ICHD - ENVIRONMENTAL HEALTH DIVISION

PERMIT # OSWP-2022-3186

SEPTIC: IMPROVEMENT PERMIT / AUTHORIZATION TO CONSTRUCT / OPERATION PERMIT / EXISTING SYSTEM

SEPTIC SUPPLY LINE EASEMENT
OF
M+J LAND INC. PROPERTY
HAGER POINT PB. 17 PG. 82

Notes for Hager Point offsite septic easements:

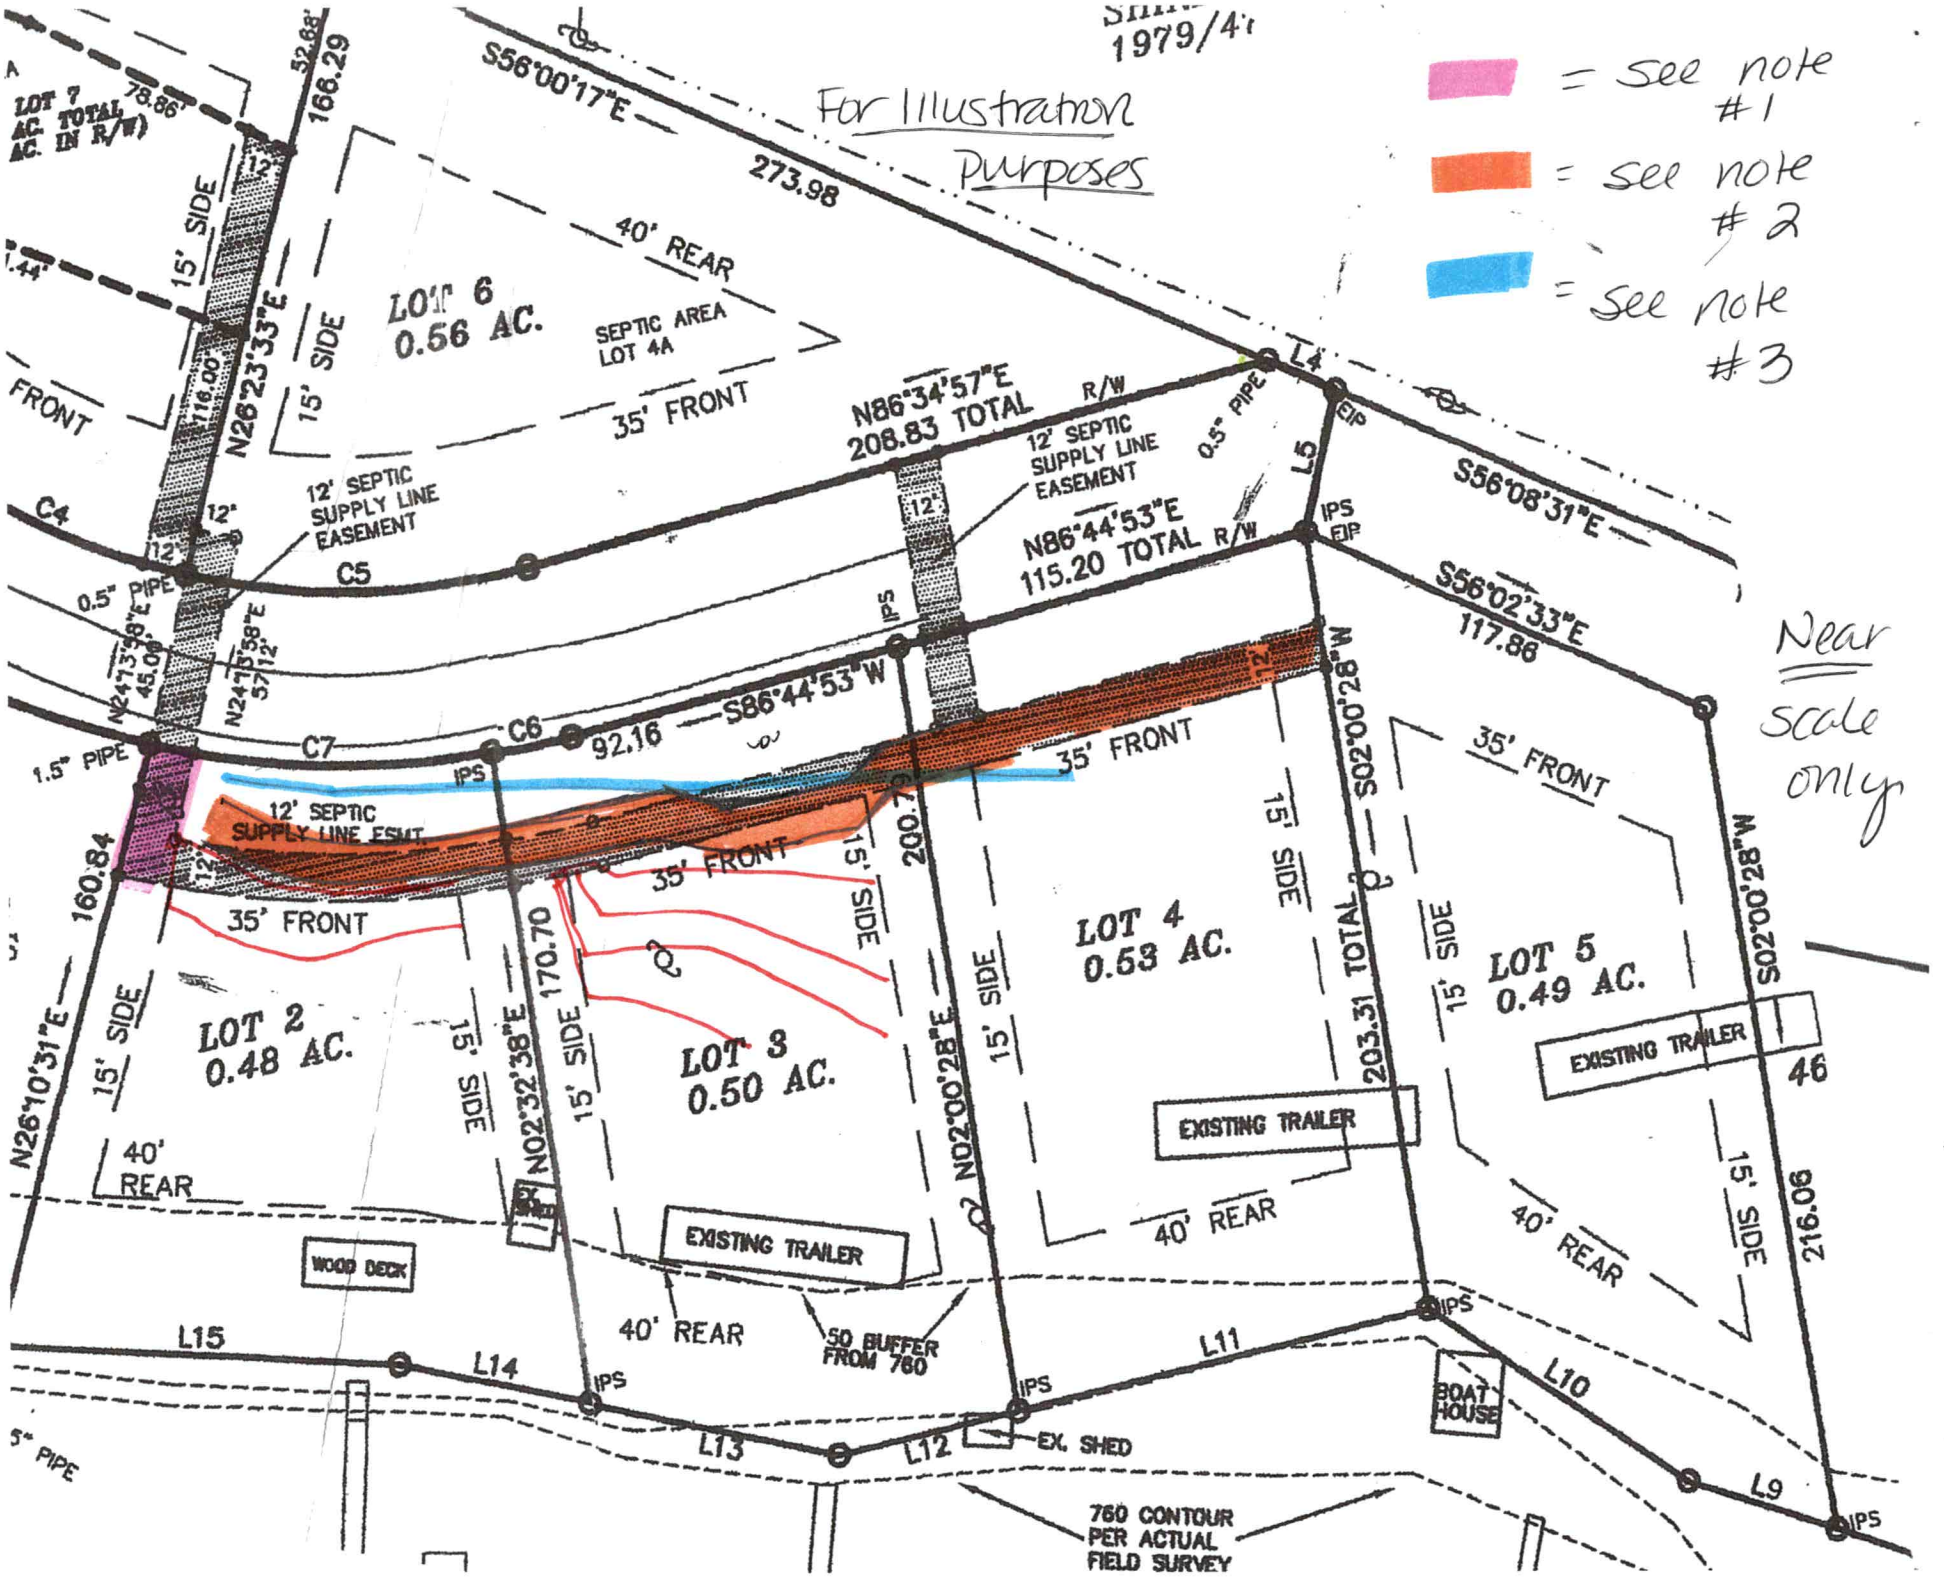
1) Move this section of the supply line easement over so it is **15'** from the power pole & the guy wires
2) Move the supply line easement up so it is a minimum of 2' from any septic drain lines indicated on AWT's original plan. Also have the power pole at the front of lot 3 shown on the plat & keep the supply line easement 15' from it & any guy wires.
    a. Do NOT use my sketch for the location of the lines or the supply line easement – have the surveyor use the original plan AWT sent. I cannot print to scale so I had to size it by enlarging it – my measurements will not be as accurate as the surveyor's
3) Include the ditch on the plat AND include a note that states as follows
    a. The supply lines must have an 18" vertical separation from the ditch at all points where they cannot meet the 10' horizontal setback
4) Include the lines surveyed in by AWT in the easement area for lot 8

Have all main power poles shown on plat – keep supply line 15' off poles & guy wires.

Include in the notes that supply lines shall be installed in separate ditches.
